Access Compliance Report

Public Rights-of-Way

Intersection ID: 32294	Main Street: STEWARTS_BEND_LN	Cross Street: SULLIVAN_RIDGE_DR	Location: SE
ADA ID: D46702D0BD30	Ramp Type: PerpDiag	Initial Pass/Fail: Fail	Overall Compliance: No
Codes/Mitigation Info/Possible Solution		Field Measurements/Component Compliance	
Severity Score: 10

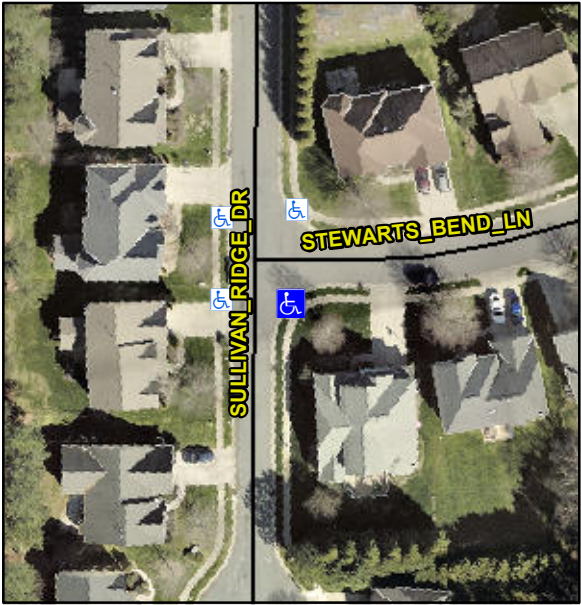
Possible Solutions:		Compliance		Description		Data	Compliance	Description	Data
	Remove & Replace Curb Ramp With Two New Directional Ramps or Equivalent.		N/A	Ramp Length (in)	49.0	Yes	Ramp Slope (%)	7.5		
<p>Surveyor Notes:</p> <p>N/A</p> <p>PROW/ADA:</p> <p>Not Found, R304.5.1, R304.5.3</p>			No	Ramp Width (in)	46.0	No	Ramp XSlope (%)	4.9		
			N/A	Flare Type LT	N/A	N/A	Flare Type RT	N/A		
			N/A	Flare Slope LT (%)	N/A	N/A	Flare Slope RT (%)	N/A		
			N/A	Flare Traversable LT?	N/A	N/A	Flare Traversable RT?	N/A		
			N/A	Landing Length (in)	N/A	N/A	DWS Provided?	N/A		
			N/A	Landing Width (in)	N/A	N/A	DWS Contrast?	N/A		
			N/A	Landing Slope (%)	N/A	N/A	DWS Length (in)	N/A		
			N/A	Landing X Slope (%)	N/A	N/A	DWS Full Width?	N/A		
			N/A	Landing Curb? (Y/N)	N/A	N/A	DWS Offset (in)	N/A		
			N/A	Shared Landing?	N/A					
			N/A	Gutter Ponding?	N/A	N/A	Gutter Slope (%)	N/A		
			N/A	Gutter Lip Ht (in)	N/A	N/A	Gutter X Slope (%)	N/A
